Safety Defect and Noncompliance Report Guide for Vehicles  
**PART 573 Defect and Noncompliance Report**<sup>3</sup>

On JAN 7<sup>th</sup>, <sup>2005</sup> 2001, Tiffin Motorhomes [MFR] decided that (a defect which relates to motor vehicle safety) (a noncompliance with Federal Motor Vehicle Safety Standard No. \_\_\_\_\_) exists in the motor vehicles listed below, and is furnishing notification to the National Highway Traffic Safety Administration in accordance with 49 CFR Part 573 Defect and Noncompliance Reports.

## Service Bulletin for Potential Movement of Washer/Dryer

PART#	MATERIAL	DESC.
Tiffin Motorhomes, Inc 502 4th Street NW P.O. Box 596 Red Bay, Alabama 35582		
TITLE: SUPPORT BOARD INSTALLATION		
MODEL: 2005 BUS, PHAETON, BAY	SCALE: NTS	
CHASSIS: ANY	DRAWN BY: RGJ	DATE: 12-22-04
CHECKED:	APPROVED:	DRAWING NO.: K:122204WASHER

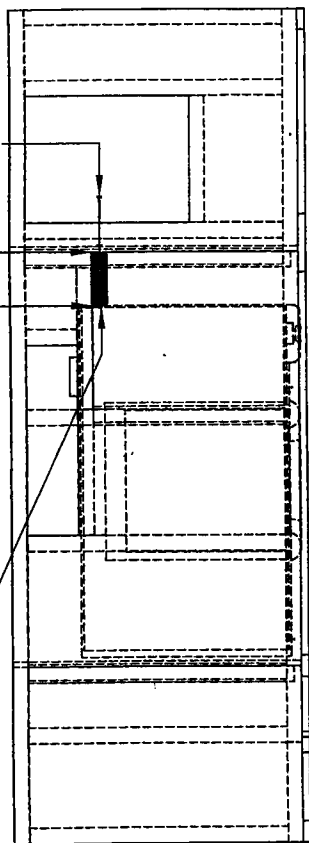
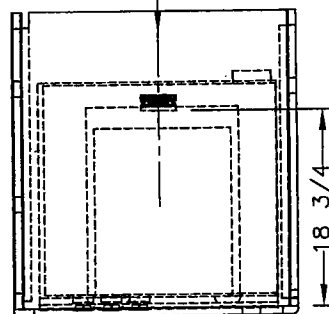
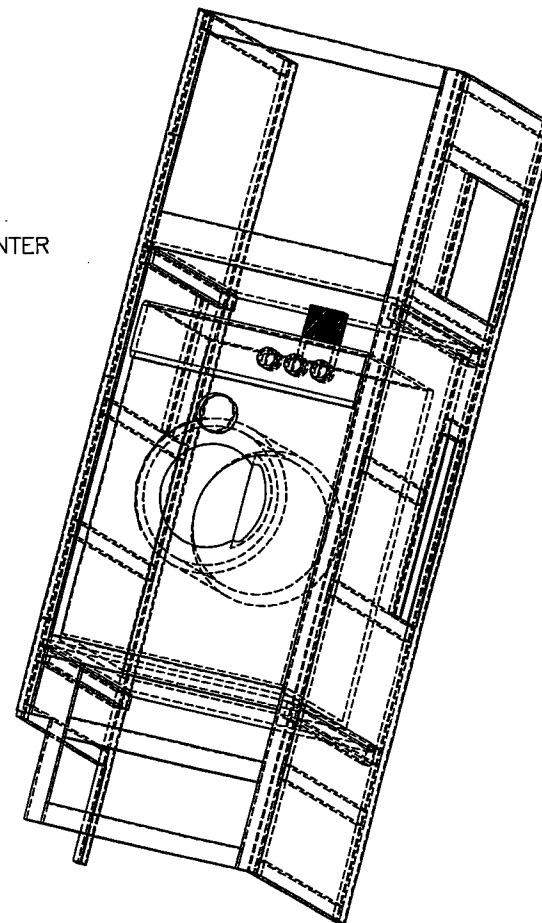
The cubby the <sup>optional</sup> washer/dryer fit into was made larger in the 2005 models in certain floorplans, allowing for potential movement.

Cause - the cubby was made larger to enable repairs to be made in the event they were needed. But as a result the washer/dryer can move.

The washer/dryer can slide out.

It has come to our attention that the piece we sent out to prevent movement of the washer/dryer is not long enough for the Zephyr units. Therefore, I am sending you a longer piece to have installed. Please take your unit to one of our dealers or a servicing center of your choice to be repaired. We will allow a quarter of an hour labor to remove the old piece and replace it with the new piece. To receive payment, please fill out the form at the bottom of the page and return it to Tiffin Motorhomes. If you are a Tiffin dealer, fill out the form and attach it to our warranty claim and send it in. If you have any questions please call Liz at 256-356-0205. We are sorry for the inconvenience of having this repair done twice.

The recall condition was corrected on our production schedule dated 12-14-04. They started installing the covered block of wood that stops potential movement of washer/dryer. However the units started on production schedule did not get to the area of the production line to be repaired until January 2005.

INSERT (2) 1 1/2" #8 WOOD SCREWS  
THROUGH SHELF INTO PADDED BOARD

CUT TO FIT BETWEEN WASHER/  
DRYER AND TOP CABINET SHELF

LOCATE ON CENTER
